Drift Pipe Upstream Endcap

Proposed change: "dish head" to flat flange

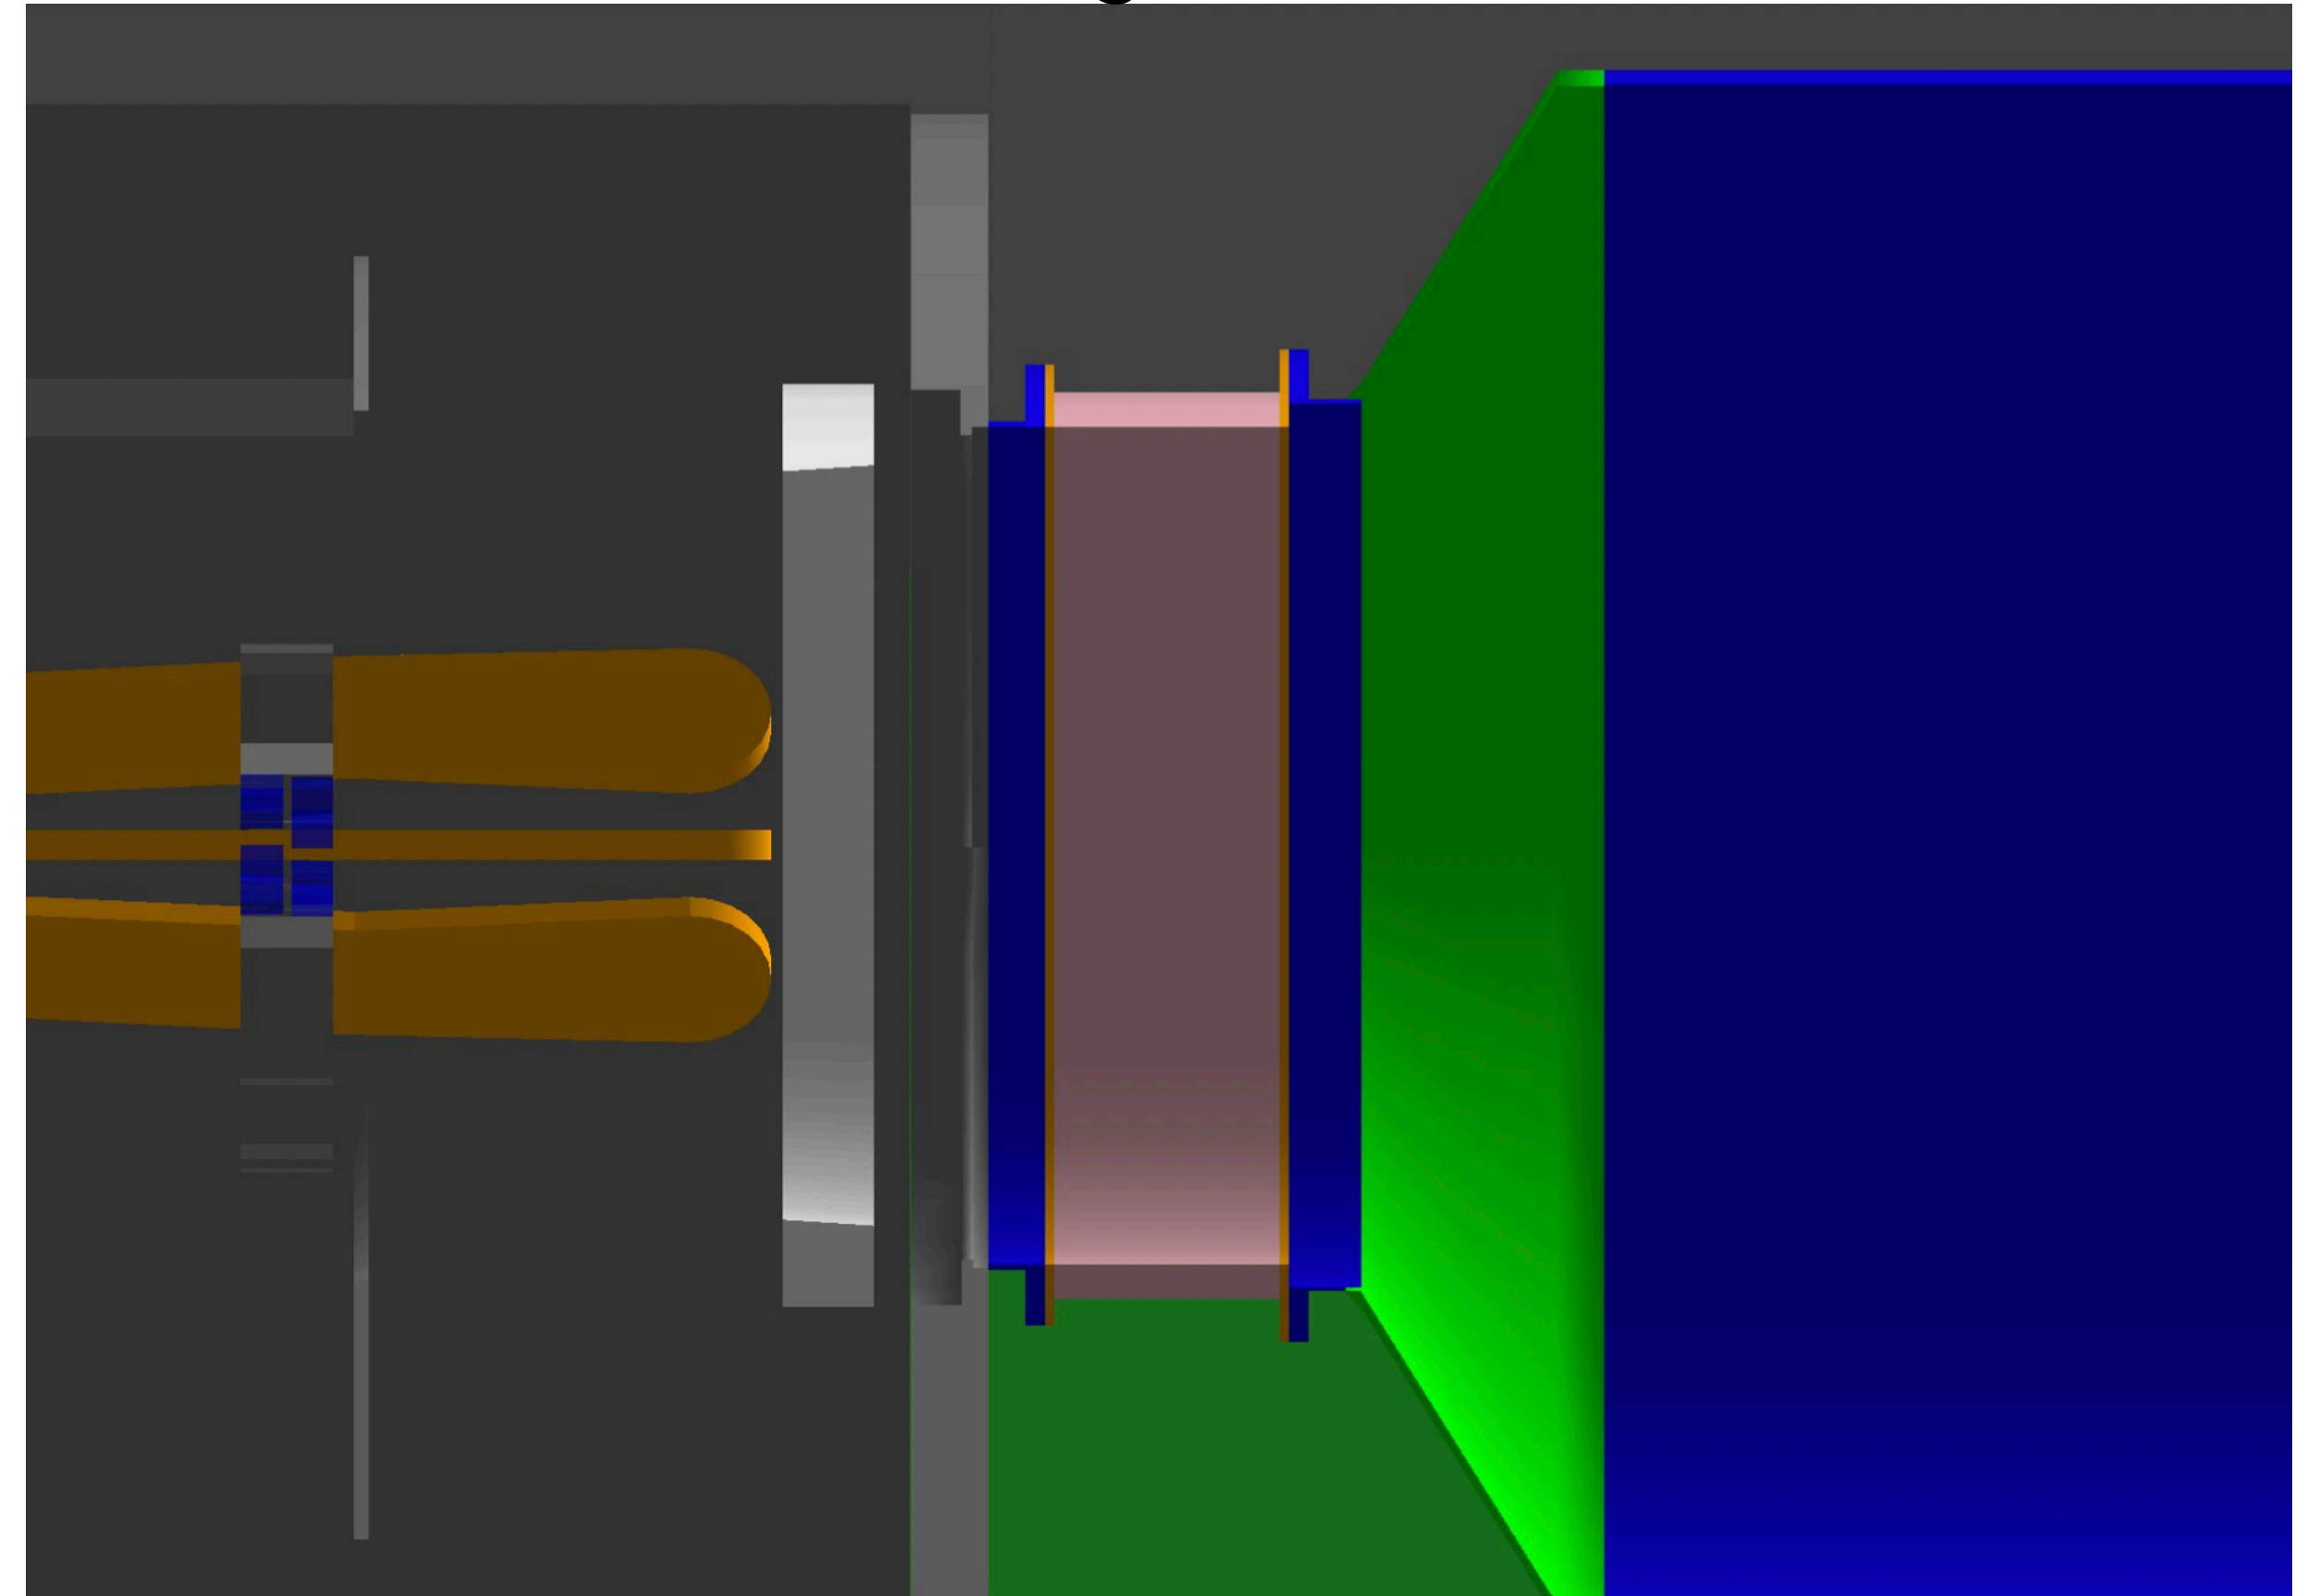
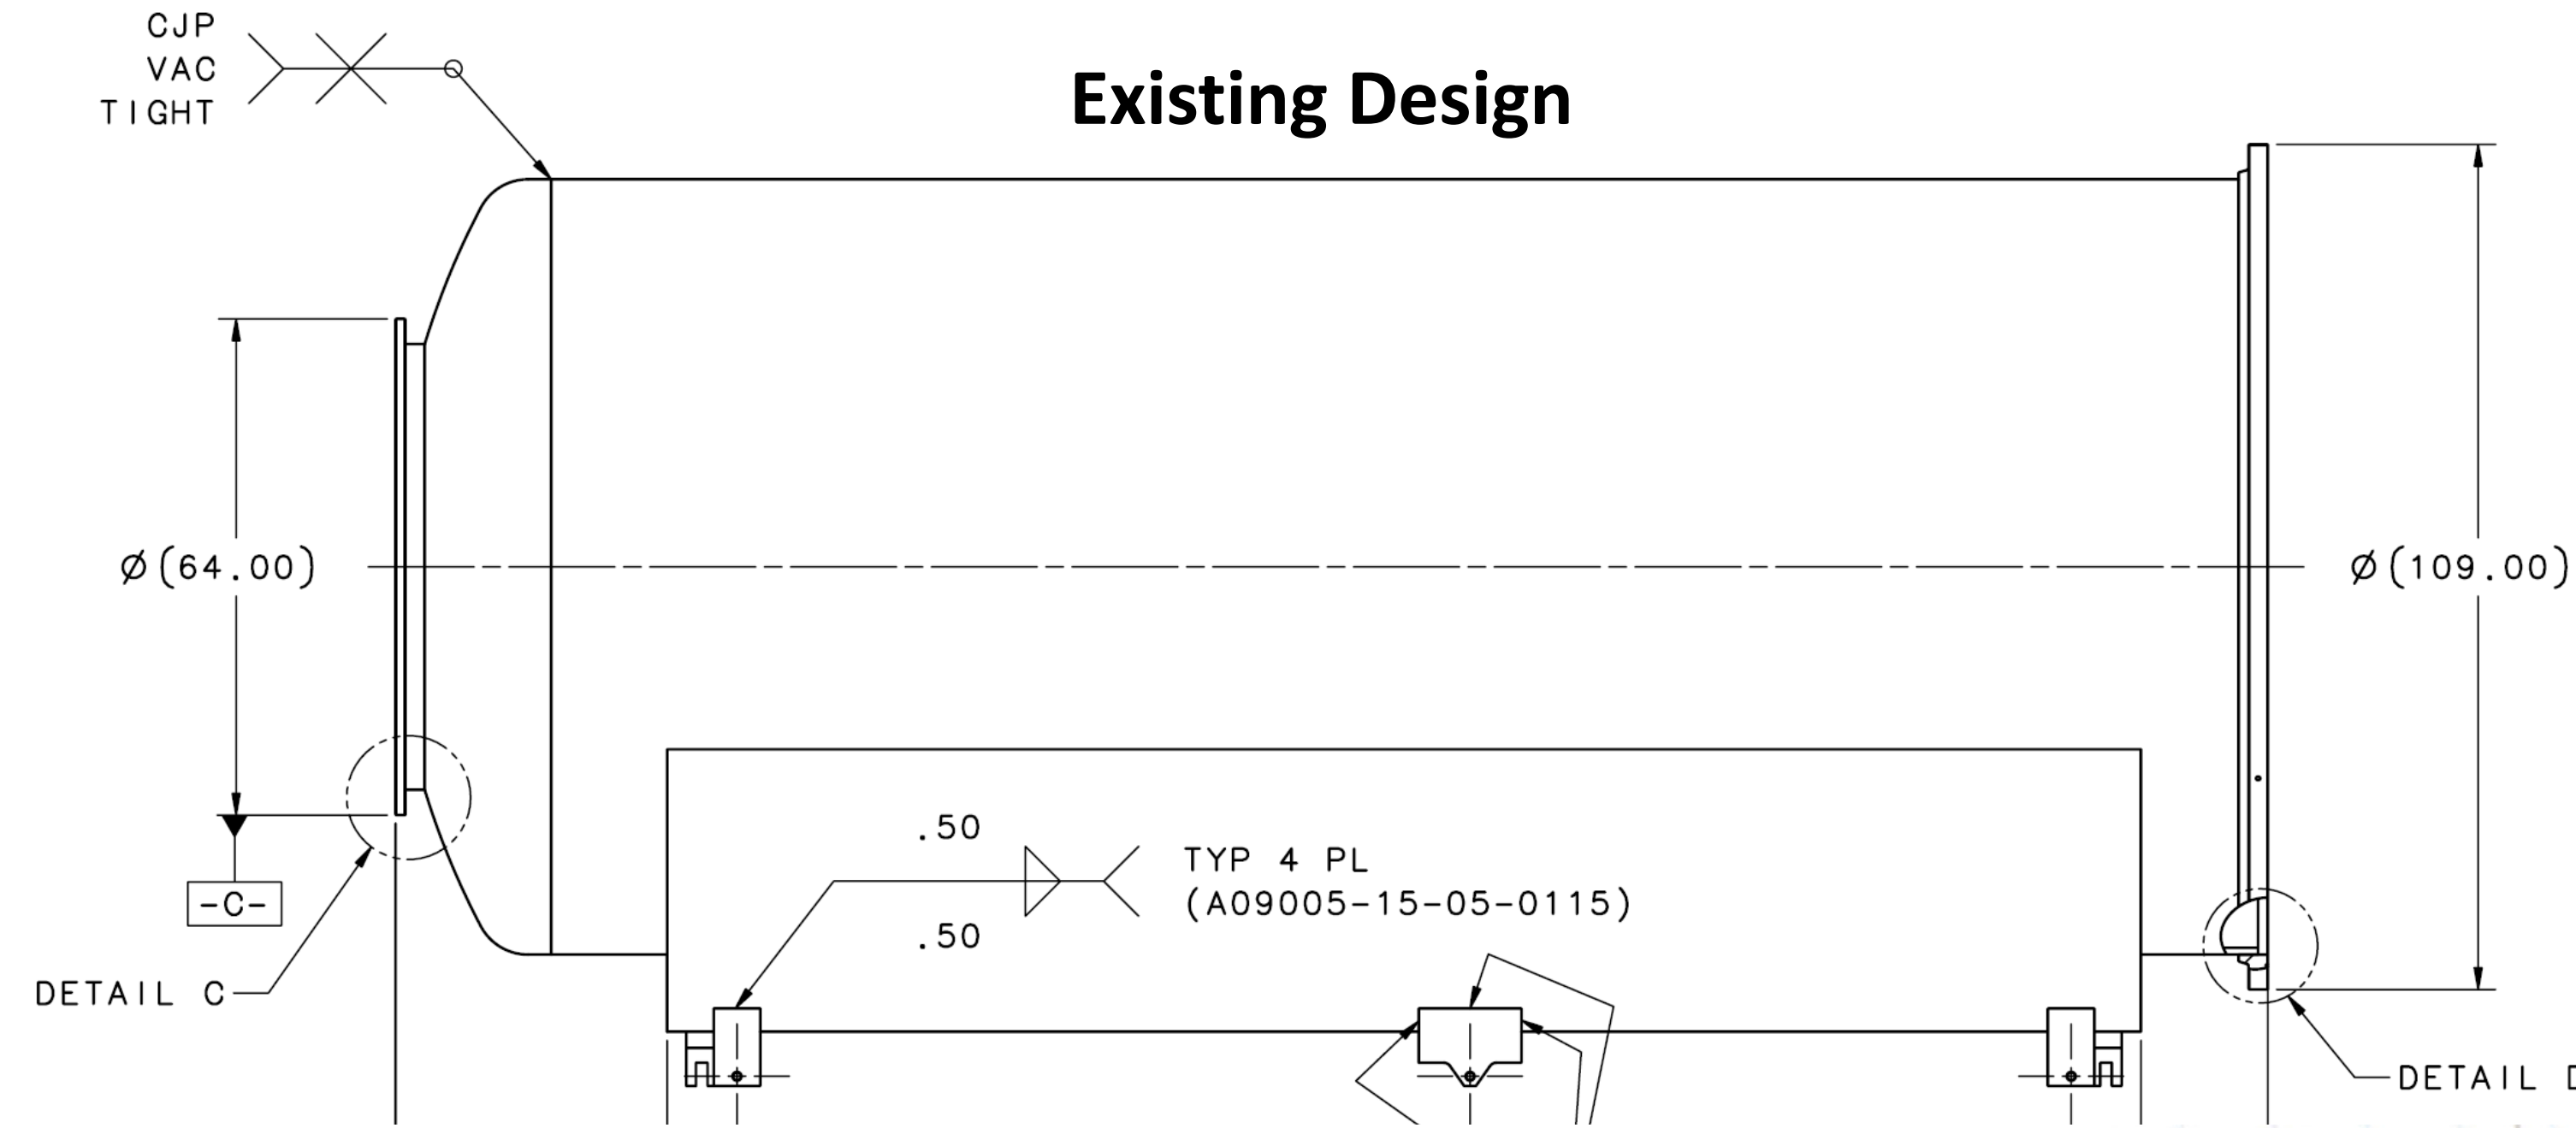
Existing Design

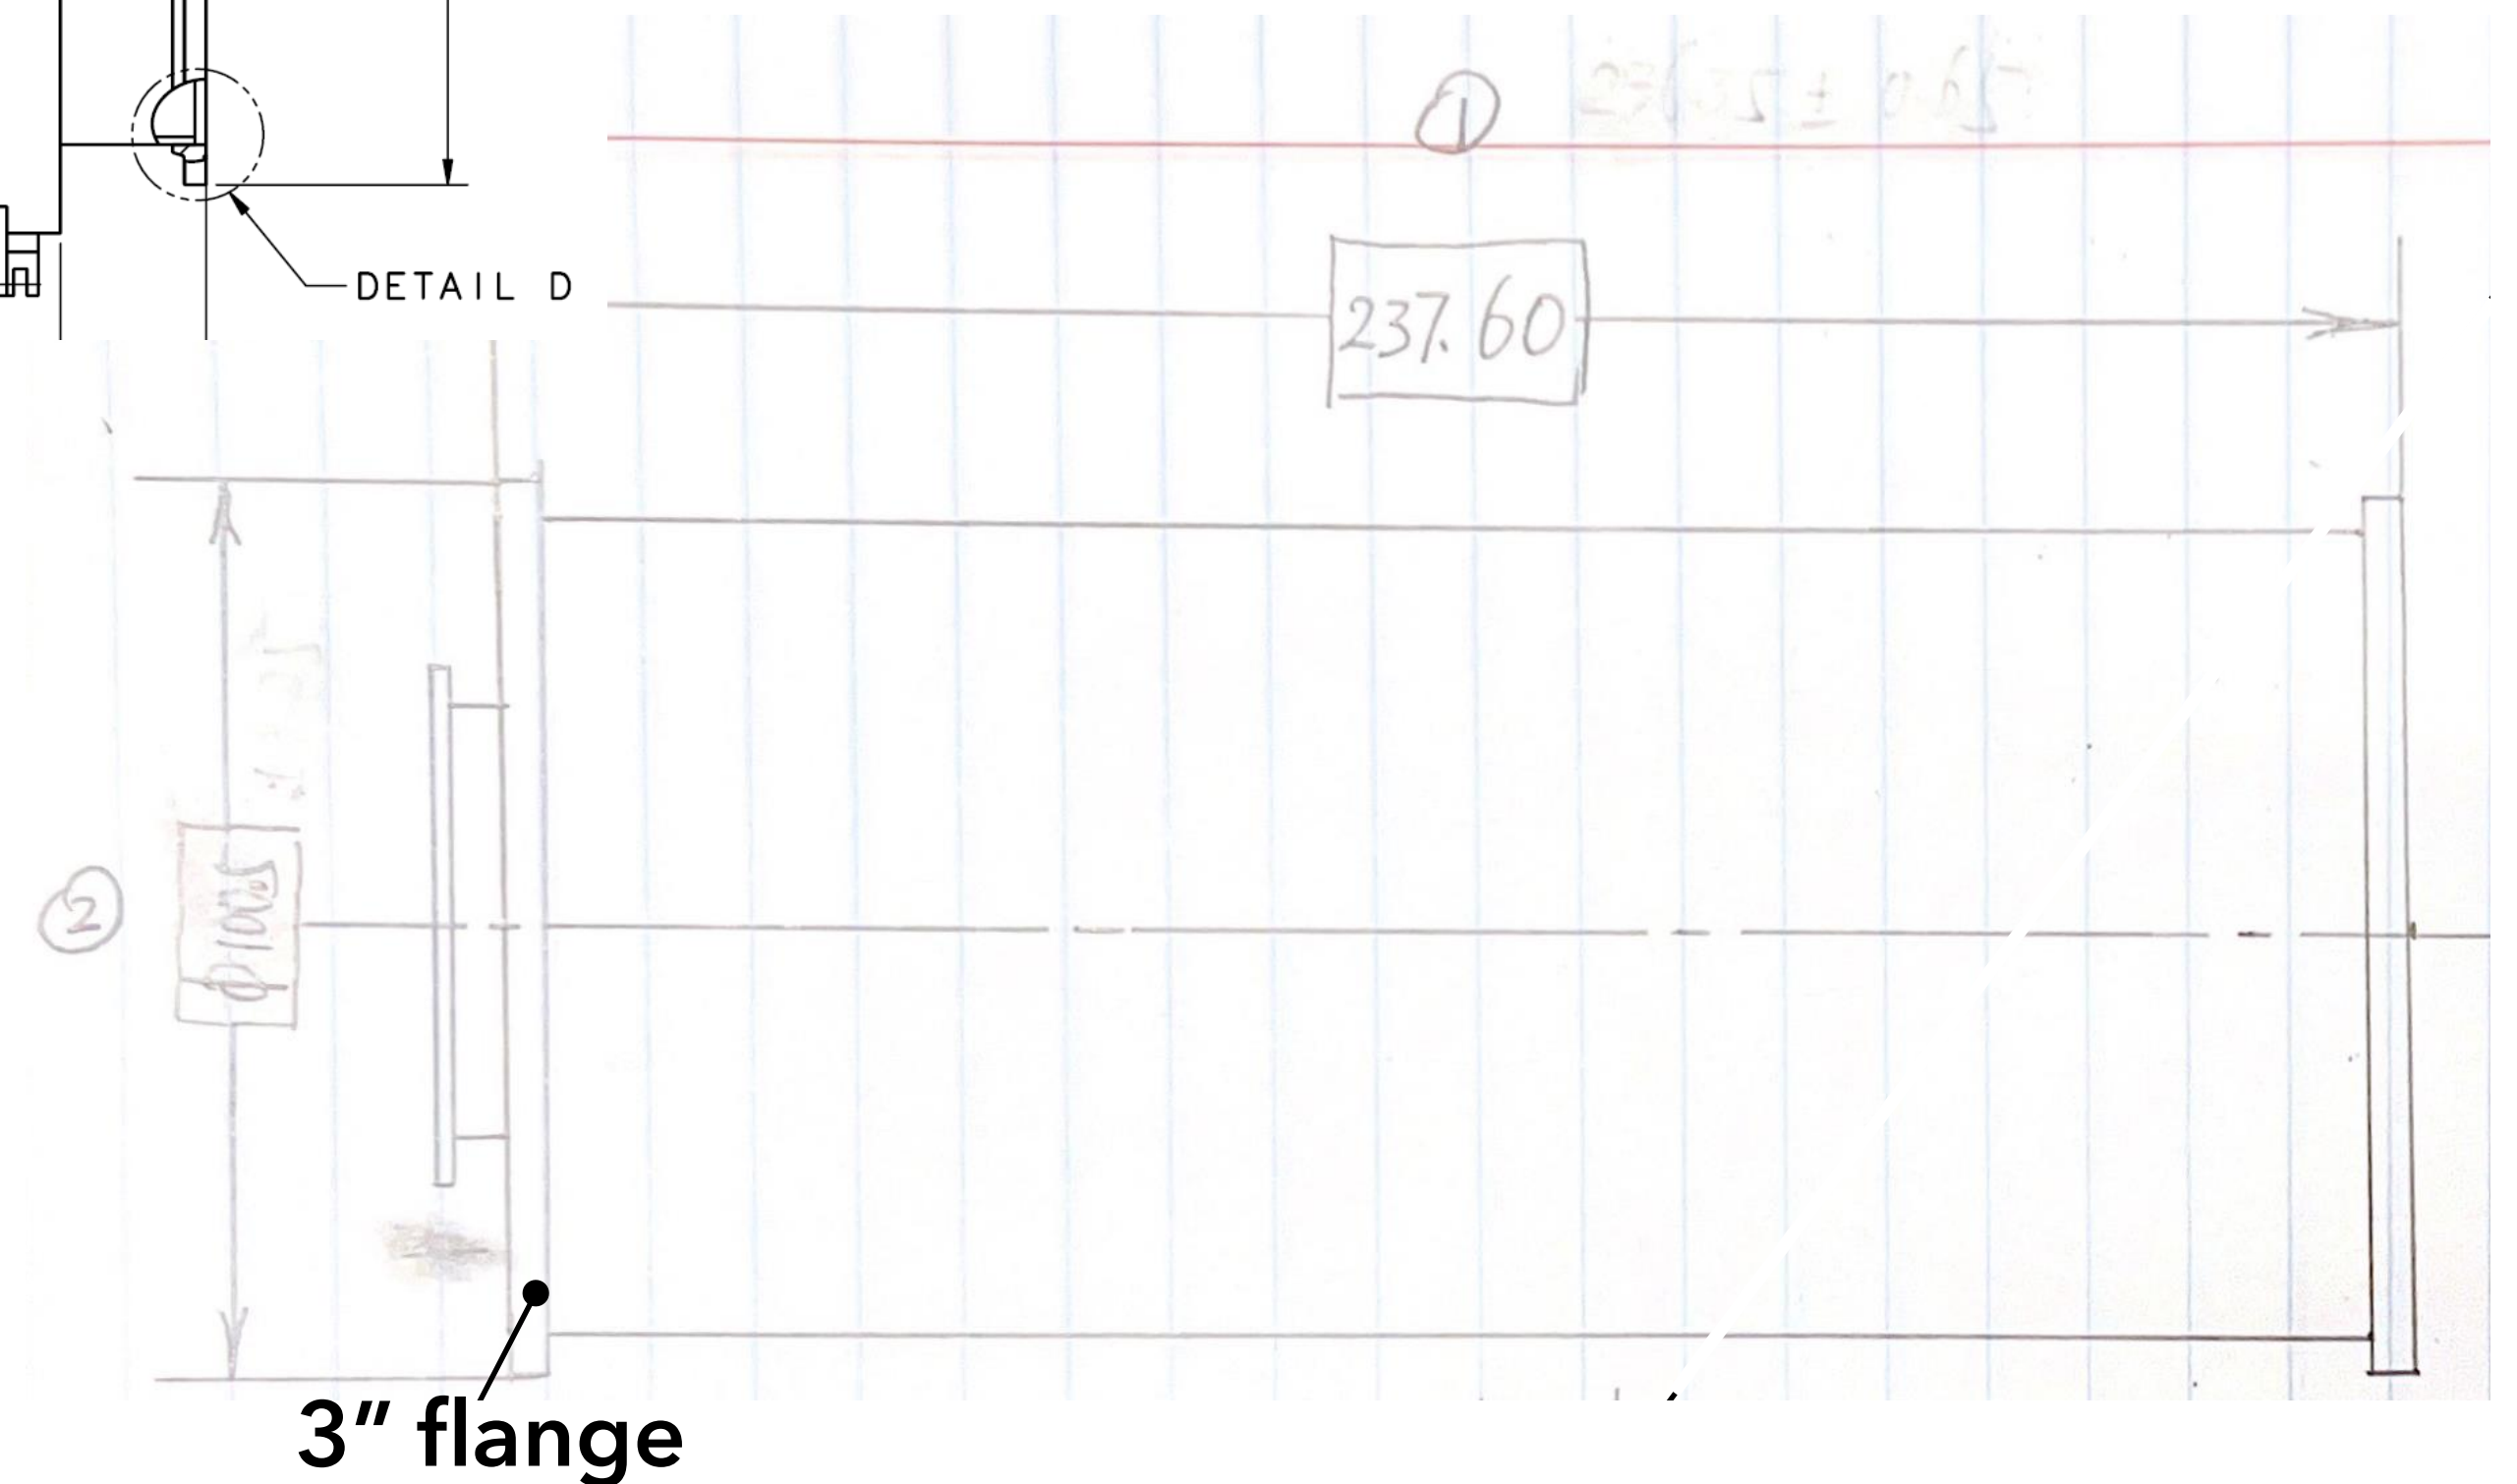
Two potential concerns:

- thicker material
- extended z-length at connection point

Is new thickness a worry?
